V2

ESP32 Pen / Laser Controller			
	ESP32 Pen / Laser Controller			
Buildlog.net	SIZE	FSCM NO.	DWG NO.	REV 2.0
	SCALE		Sheet 1

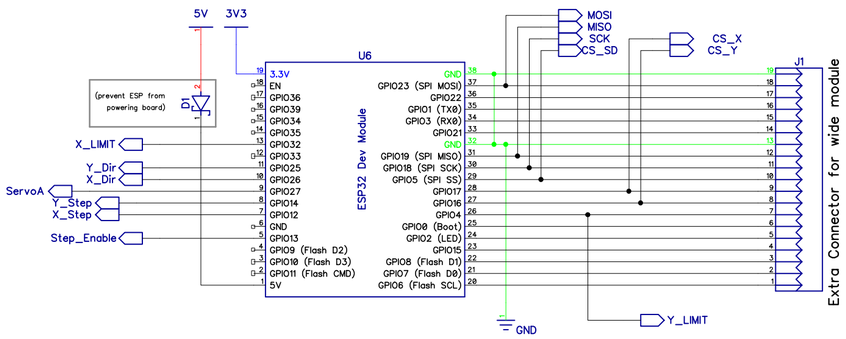
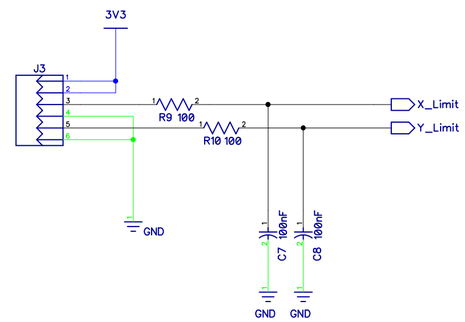
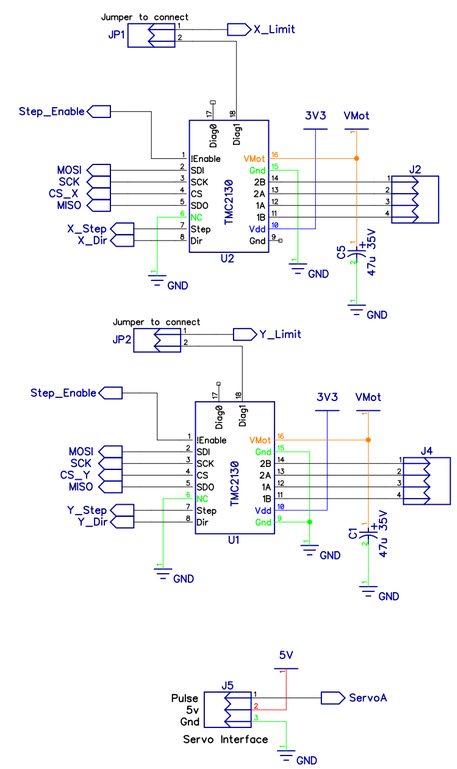
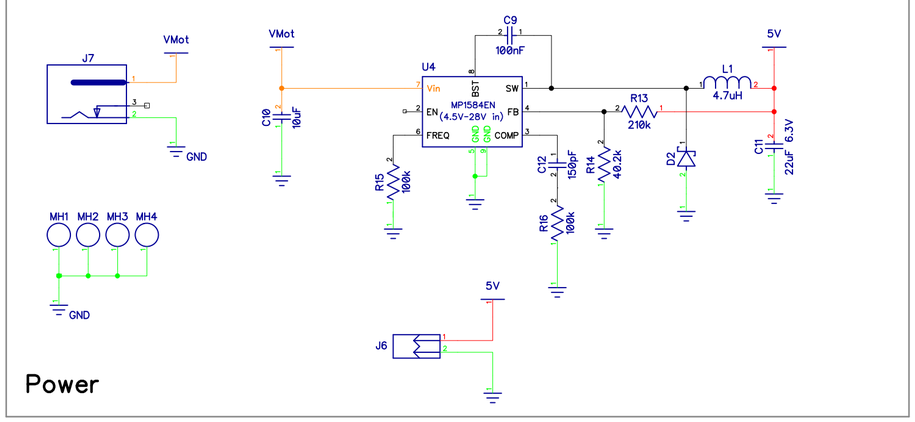
1. Moved X_Limit from GPIO 2 to 32
2. change drivers to diag footprint
3. Added jumpers to connect diag1 to limits
4. Grounded TMC2130 N/C pin for TMC5160 compatibility
5. Added 5V fan connector
